Access Compliance Report

Public Rights-of-Way

(Curb Ramps)

Intersection ID: 49321	Main Street: WHITEBEAM_WY	Cross Street: HUNTERS_MOON_LN	Location: SE
ADA ID: 72579A31A9C8	Ramp Type: Perp	Initial Pass/Fail: Fail	Overall Compliance: No
Severity Score: 37.5			
Codes/Mitigation Info/Possible Solution		Field Measurements/Component Compliance

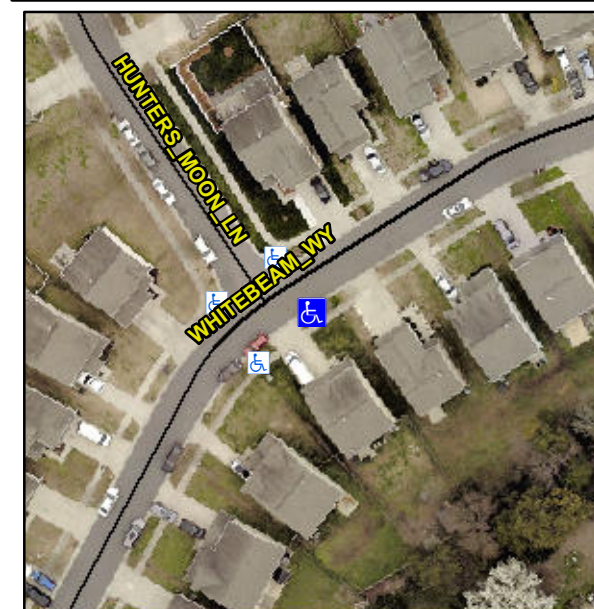
Not Found, R304.2.2, R304.5.3

Compliance	Description	Data	Compliance	Description	Data
N/A	Ramp Length (in)	73.0	No	Ramp Slope (%)	10.4
Yes	Ramp Width (in)	48.0	No	Ramp XSlope (%)	9.3
N/A	Flare Type LT	N/A	N/A	Flare Type RT	N/A
N/A	Flare Slope LT (%)	N/A	N/A	Flare Slope RT (%)	N/A
N/A	Flare Traversable LT?	N/A	N/A	Flare Traversable RT?	N/A
N/A	Landing Length (in)	N/A	N/A	DWS Provided?	N/A
N/A	Landing Width (in)	N/A	N/A	DWS Contrast?	N/A
N/A	Landing Slope (%)	N/A	N/A	DWS Length (in)	N/A
N/A	Landing X Slope (%)	N/A	N/A	DWS Full Width?	N/A
N/A	Landing Curb? (Y/N)	N/A	N/A	DWS Offset (in)	N/A
N/A	Shared Landing?	N/A			
N/A	Gutter Ponding?	N/A	N/A	Gutter Slope (%)	N/A
N/A	Gutter Lip Ht (in)	N/A	N/A	Gutter X Slope (%)	N/A
N/A	Painted X Walk1?	No	N/A	Painted X Walk2?	N/A
	X Walk 1 Direction	To NW		X Walk 2 Direction	N/A
N/A	X Walk 1 Width (in)	N/A	N/A	X Walk 2 Width (in)	N/A
	X Walk 1 Slope (%)	3.8		X Walk 2 Slope (%)	N/A
	X Walk 1 X Slope (%)	5.0		X Walk 2 X Slope (%)	N/A

Possible Solutions:

Remove & Replace Entire Ramp.
